STAFF REPORT

Planning Commission Meeting: October 28, 2019

Application: RZ19-0022: Rezoning from R-1 and RP-1 to the R-1 District and

preliminary plat for Stonebridge Village

View of subject property, existing sidewalks (green) and the missing sidewalk link (red)

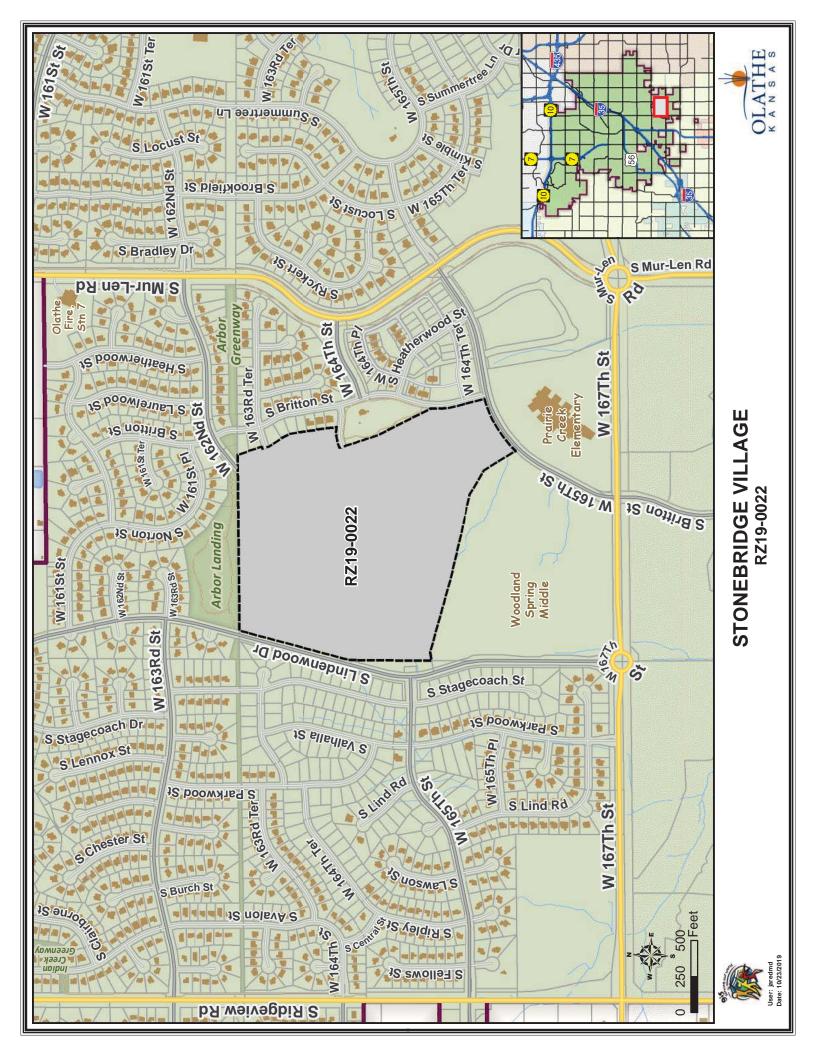
Staff has since received several phone calls and a letter, which is included in this packet, from the Spring Hill School District regarding concerns with stormwater management on site and a missing sidewalk link along the north side of W. 165th Street. From the onset of this application review, staff requested the sidewalk connection be provided with construction of the first phase of development. The image on the next page shows where there are existing sidewalks in the right-of-way (green) compared to the missing sidewalk

link (red). The missing link in the sidewalk is approximately 430 feet in length and would connect the existing sidewalk that terminates at the school's property line along 165th Street to the west side of Britton Street. On the east side of Britton Street, there is a sidewalk that extends north to 164th Street, and east to Mur-Len Road. The school district was advised that the City would be recommending this sidewalk connection through Tract F of the preliminary plat to provide improved pedestrian access.

This connection is important to provide a safe route for residents and children to feel comfortable walking to and from the schools without crossing the street mid-block. Providing this connection also aligns with Policy M-3.8 of PlanOlathe, the City's Comprehensive Plan, which states, "Pedestrian and bikeway paths should provide connections between residential and employment areas, commercial centers, recreational and open space areas, parks and educational facilities." Staff has had several discussions with the applicant regarding this sidewalk connection and has made them aware of this stipulation, however the applicant is not amenable constructing this connection at this time. Additional information on this is provided later in this report.

- 3. A 5-foot wide concrete sidewalk must be constructed with the first phase in Tract F, along the north side of W. 165th Street, tying into the sidewalk at the adjacent property line of Woodland Spring Middle School and extending northeasterly to S. Britton Street.
